## HISTORIC AND DESIGN REVIEW COMMISSION

**HDRC CASE NO:** 2020-064  
**ADDRESS:** 3801 BROADWAY  
**LEGAL DESCRIPTION:**  
**ZONING:** R-6, RIO-1, H  
**CITY COUNCIL DIST.:** 2  
**LANDMARK:** Brackenridge Park/Witte Museum  
**TYPE OF WORK:** Restoration of Twohig house  
**APPLICANT:** John Speegle  
**APPLICATION RECEIVED:** January 31, 2020  
**60-DAY REVIEW:** March 31, 2020  
**CASE MANAGER:** Edward Hall

### **Conceptual Approval for the Renovation of the Twohig House**

**SKDA: 20002 A-3.0**

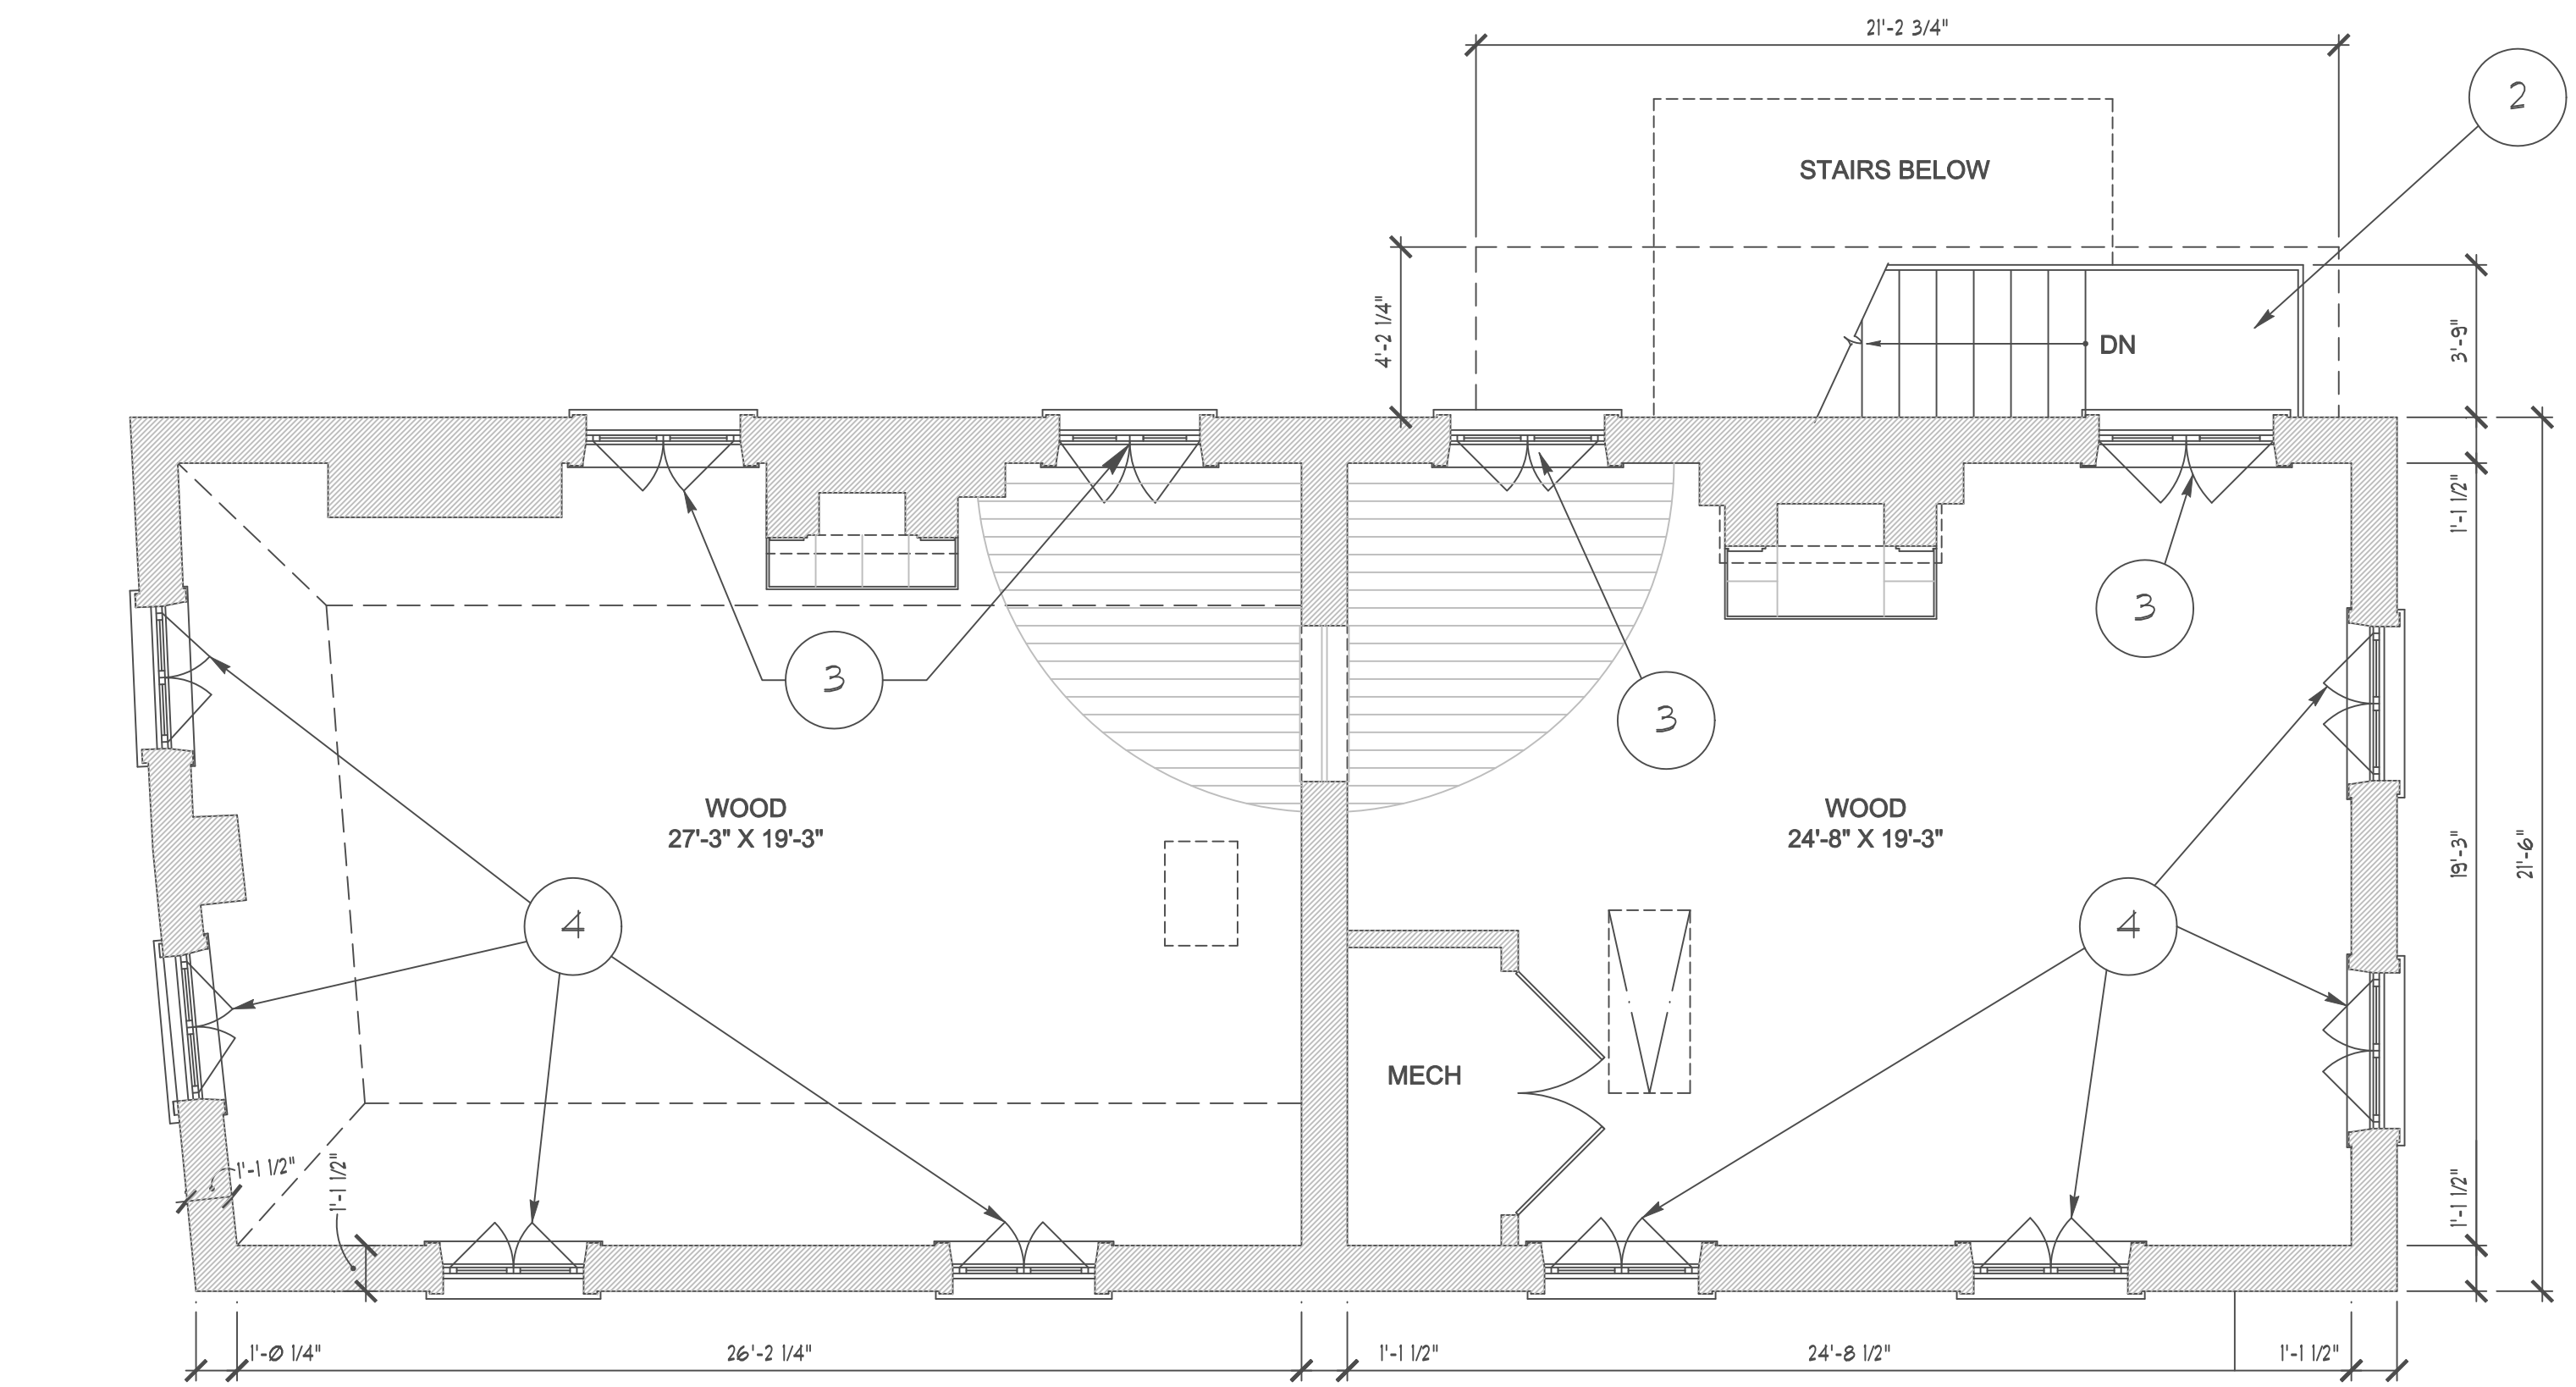
- g. **EXTERIOR STAIR** – The applicant has proposed to reconstruct a non-original exterior egress stair on the structures west (rear) elevation. Staff finds the proposed location and profile to be appropriate.

Staff recommends approval of items #1 through #5 based on findings a through g with the following stipulations:
